RFI response #2

Troup Co Court Room 3C

24-01920

1 DEMOLITION PLAN
 D1.1 SCALE: 1/4" = 1'-0"

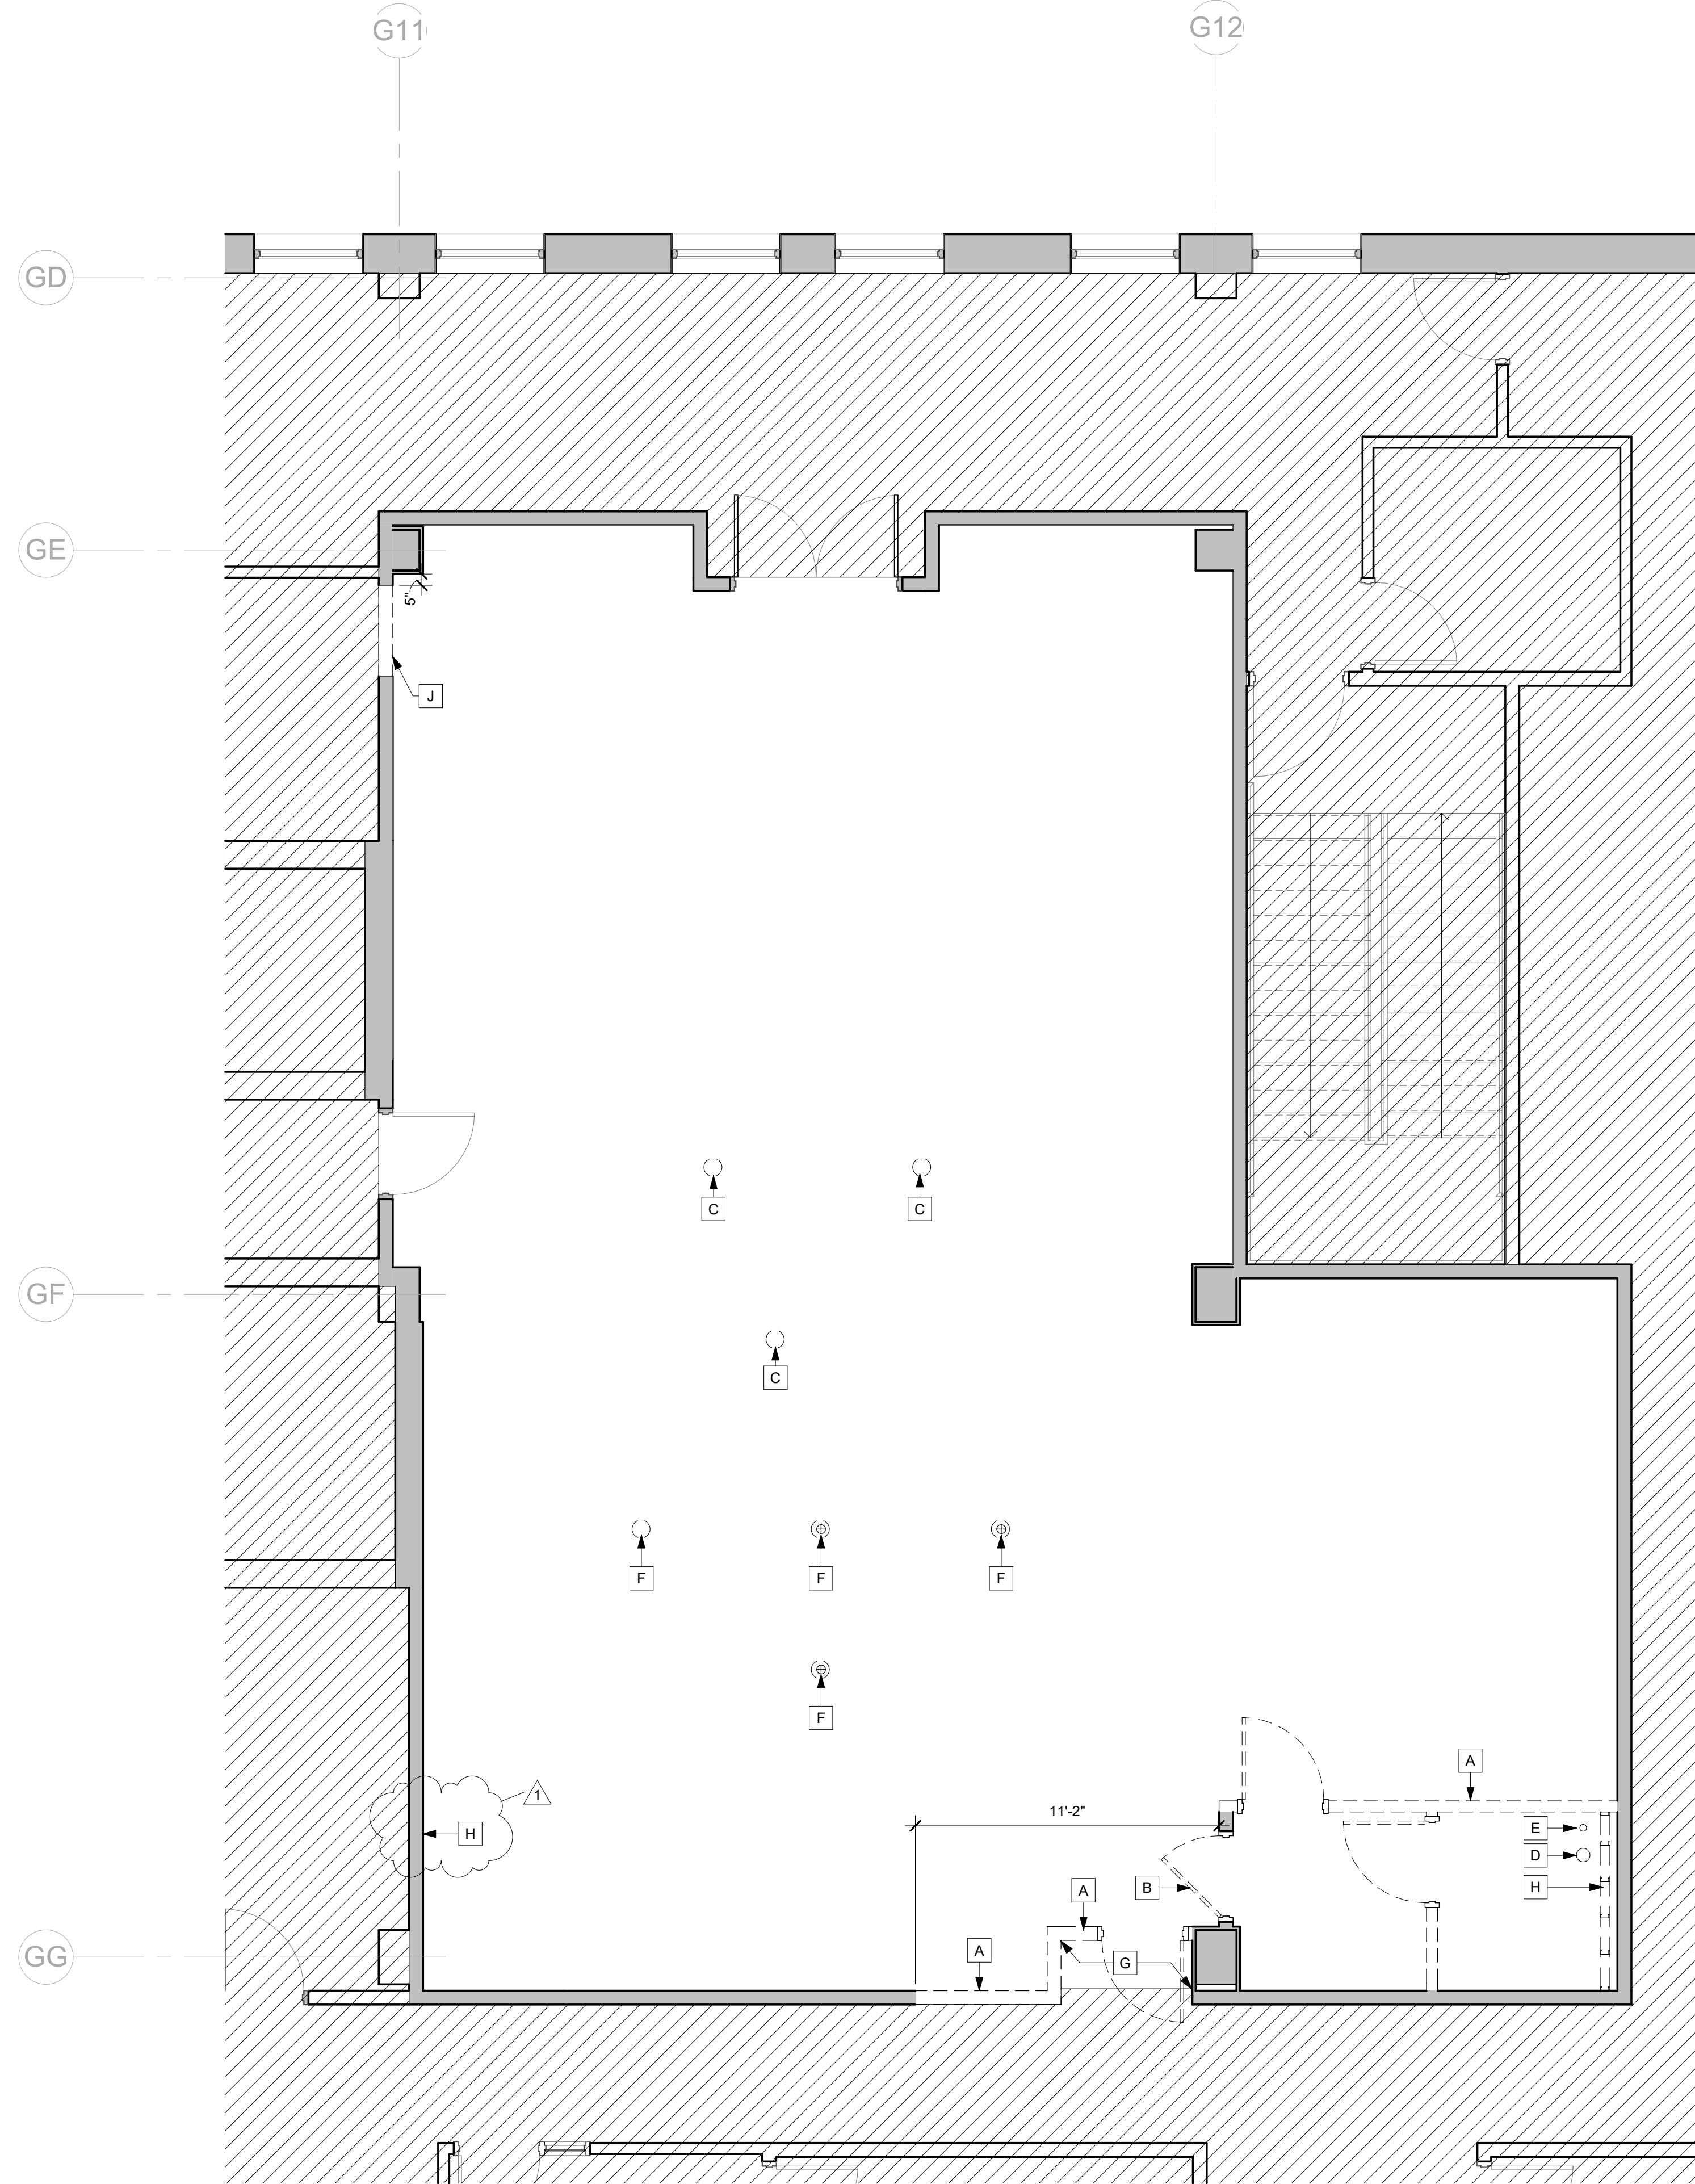
1. In reference: note "J" in the NW corner of sheet D1.1, is the construction of the existing wall stud and gypsum or masonry/concrete?

Response: Existing wall is CMU masonry with gypsum board on hat channels.

NEW CONSTRUCTION FLOOR PLAN -
COURTROOM #8

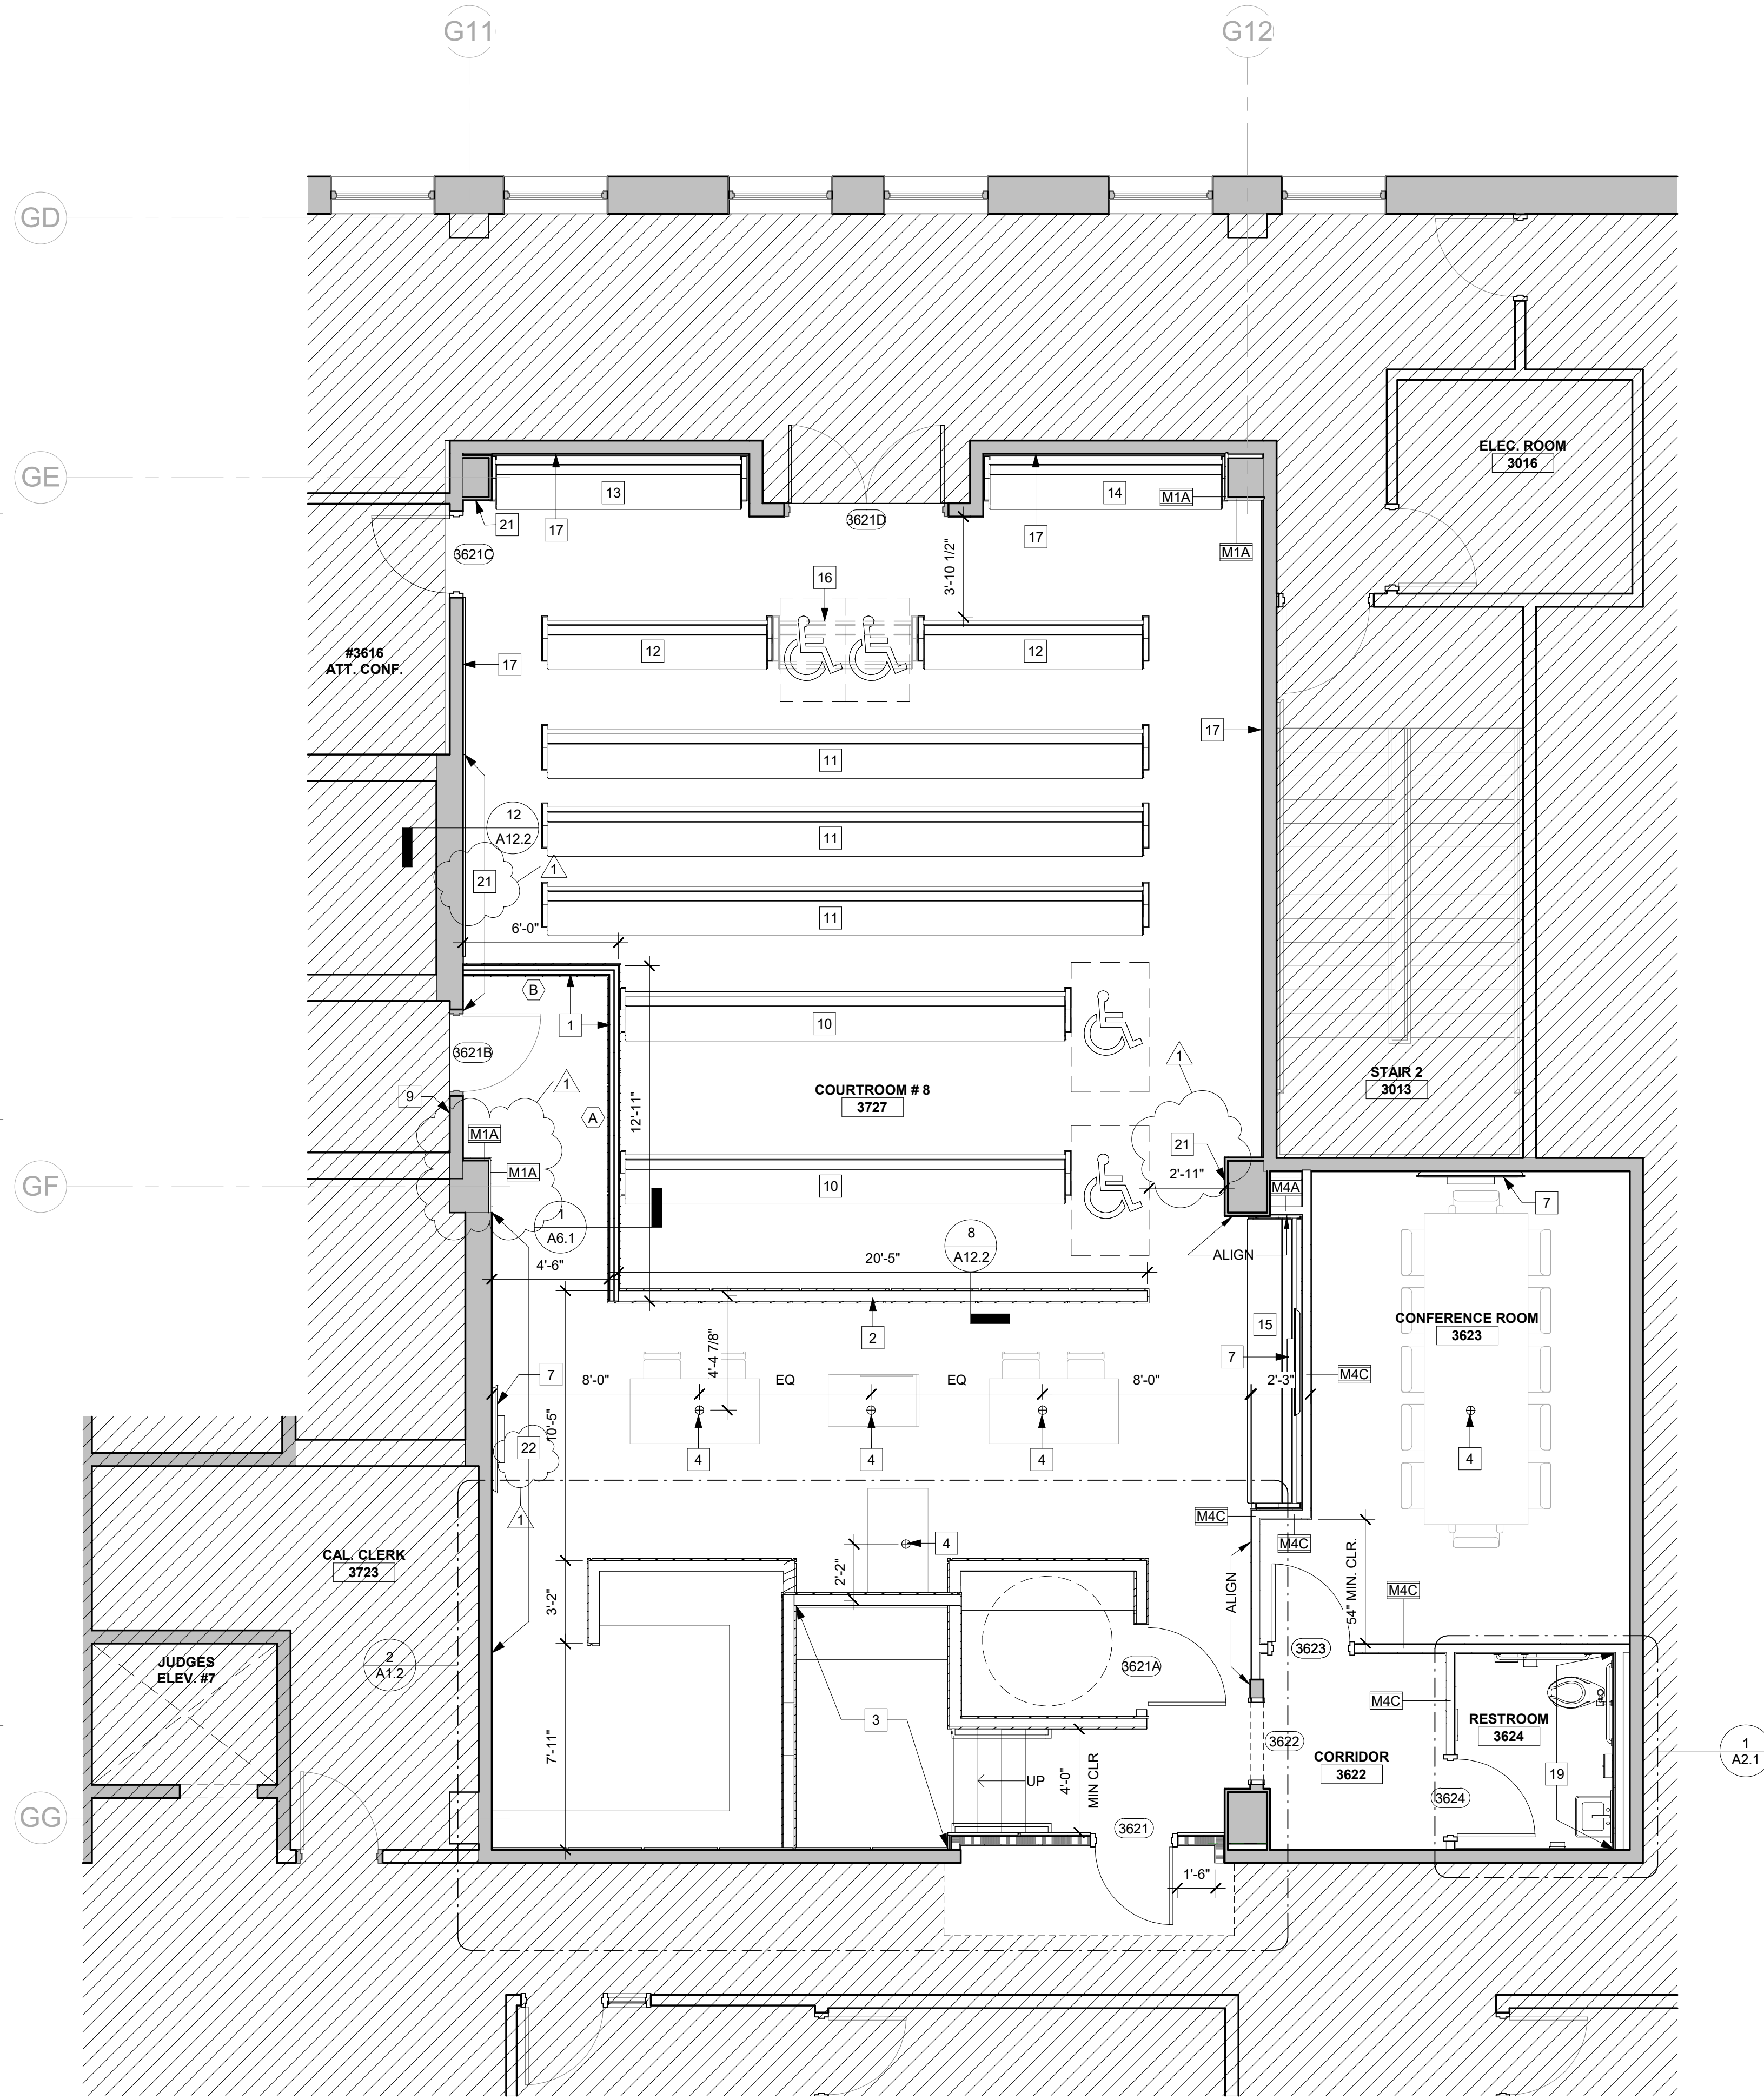
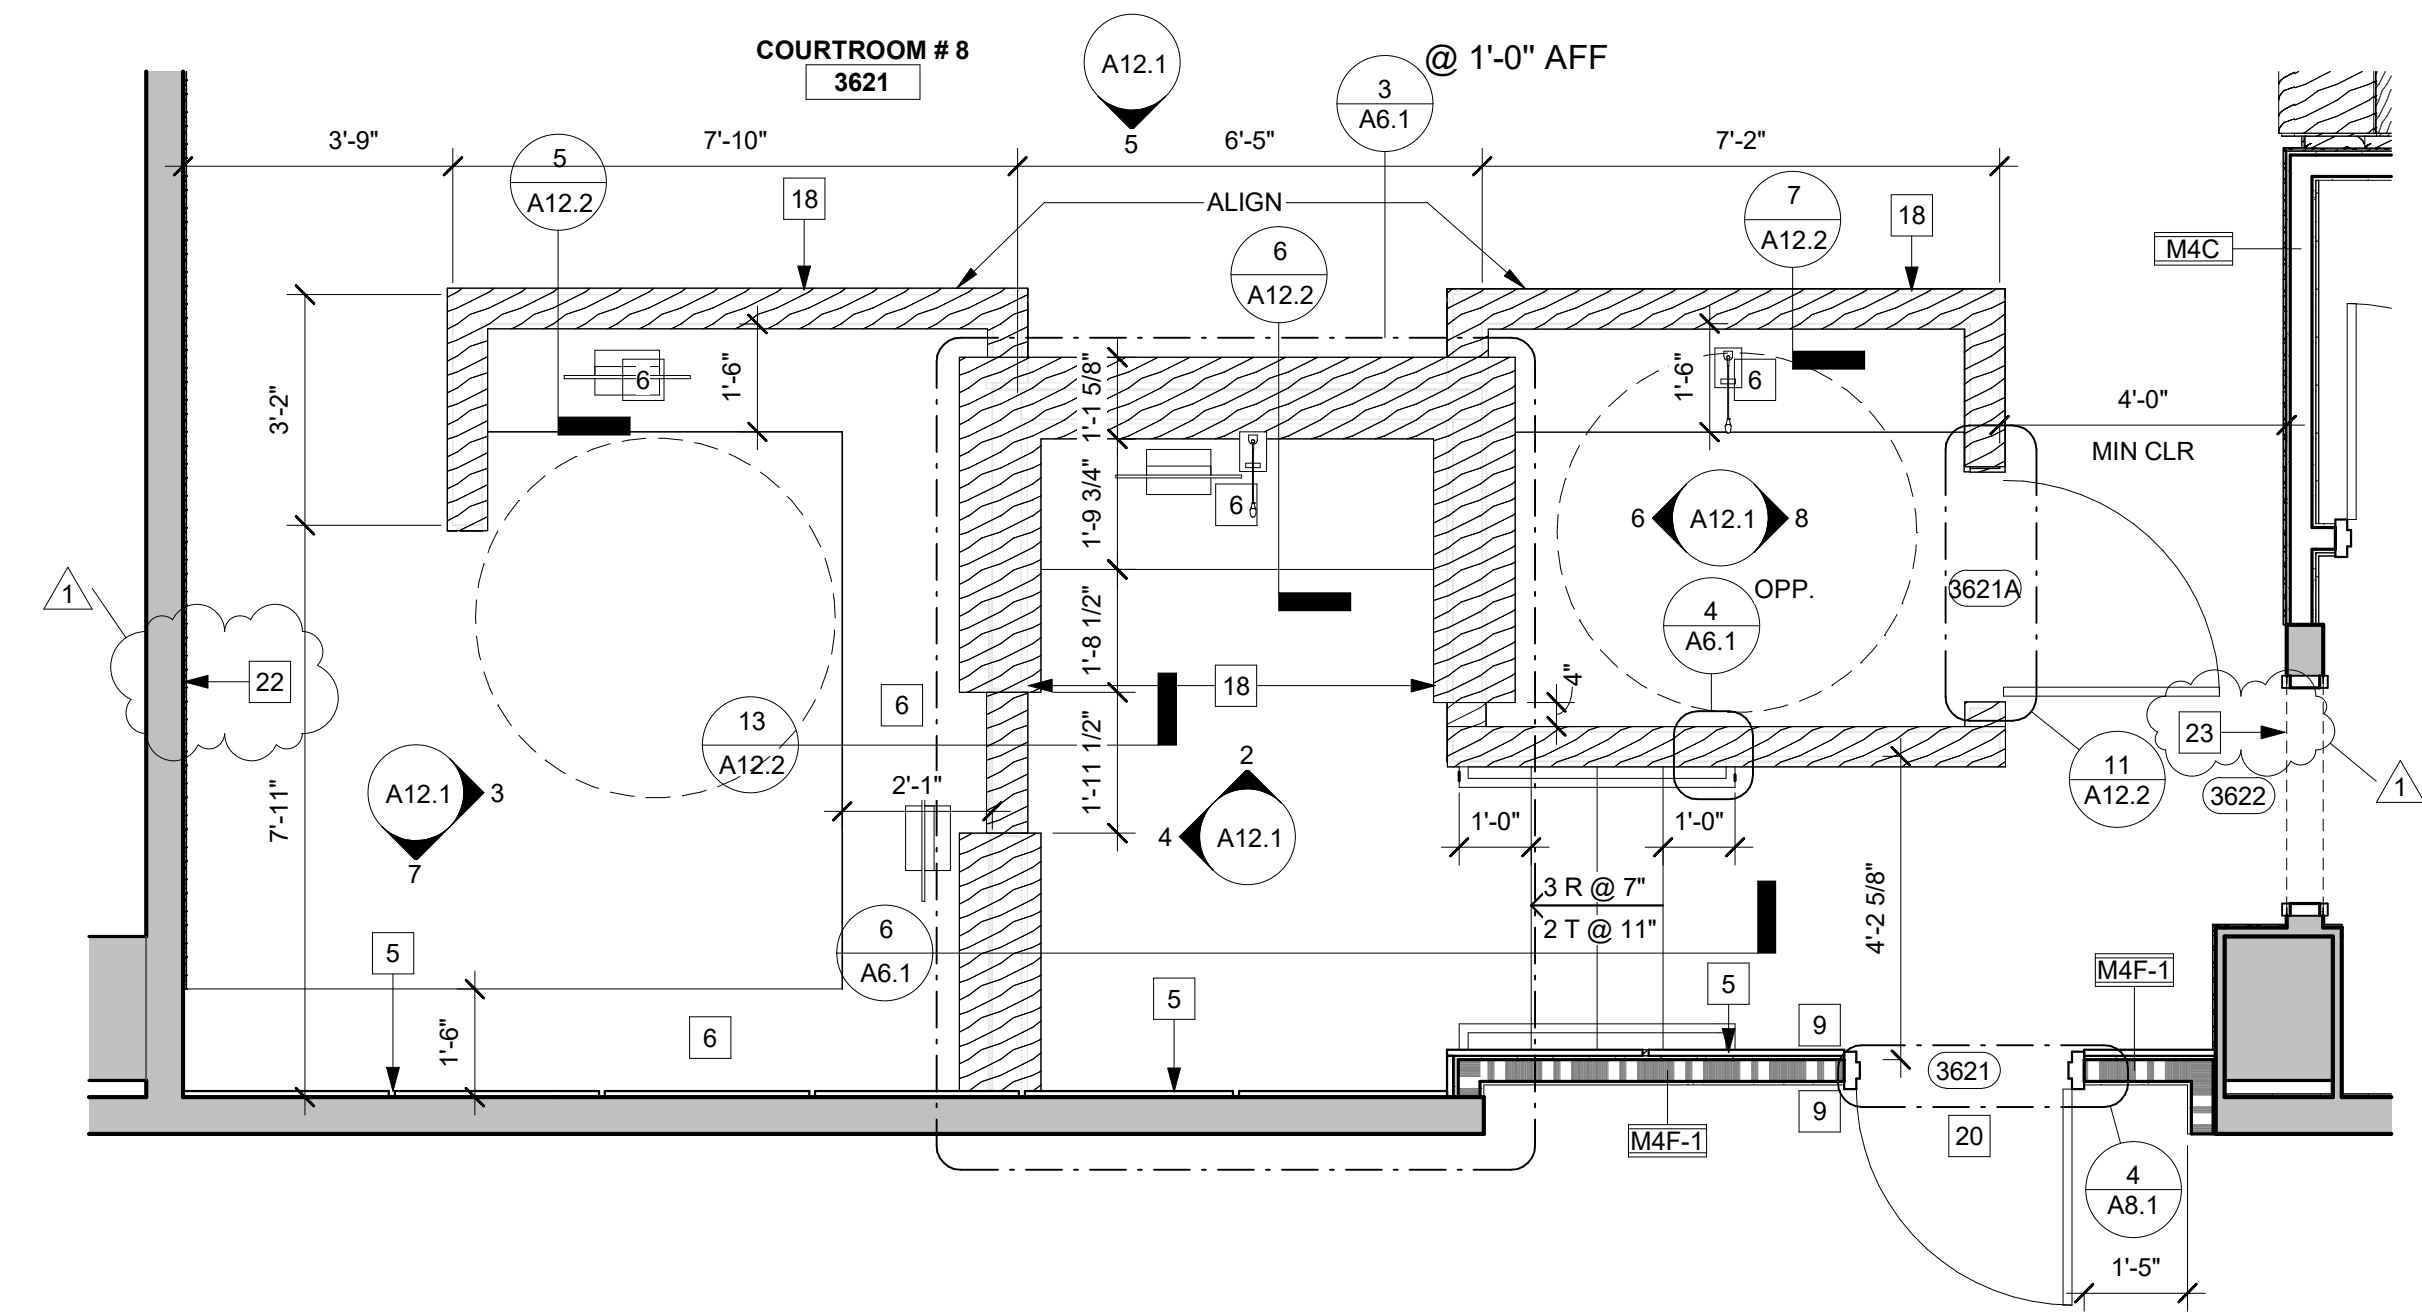
8. The door numbers on the new sheet A1.2 do not match up with the door numbers on the original A8.1 door schedules

10. Door 3621 (Judges entrance) was previously in a 1-hour fire wall. See LSF1.1. This is now noted to be door number 127 in a type M4C which is a non-rated full height wall. Clarify this door opening as to wall rating?

11. Door 3621C is now door 128 and was previously a 45 rating on the door schedule. Clarify this door opening as to wall rating?

Response: Plan Sheets A1.2 and A9.1 labeled not for construction and included in Pre-Bid Meeting Notes dated February 18, 2025 are for AV reference only. All other information needs to reference the full set of signed and sealed documents dated 11/20/2024 and Addendum 1 dated 3/17/2025.

Response: Plan Sheets A1.2 and A9.1 labeled not for construction and included in Pre-Bid Meeting Notes dated February 18, 2025 are for AV reference only. All other information needs to reference the full set of signed and sealed documents dated 11/20/2024 and Addendum 1 dated 3/17/2025.

Response: Plan Sheets A1.2 and A9.1 labeled not for construction and included in Pre-Bid Meeting Notes dated February 18, 2025 are for AV reference only. All other information needs to reference the full set of signed and sealed documents dated 11/20/2024 and Addendum 1 dated 3/17/2025.
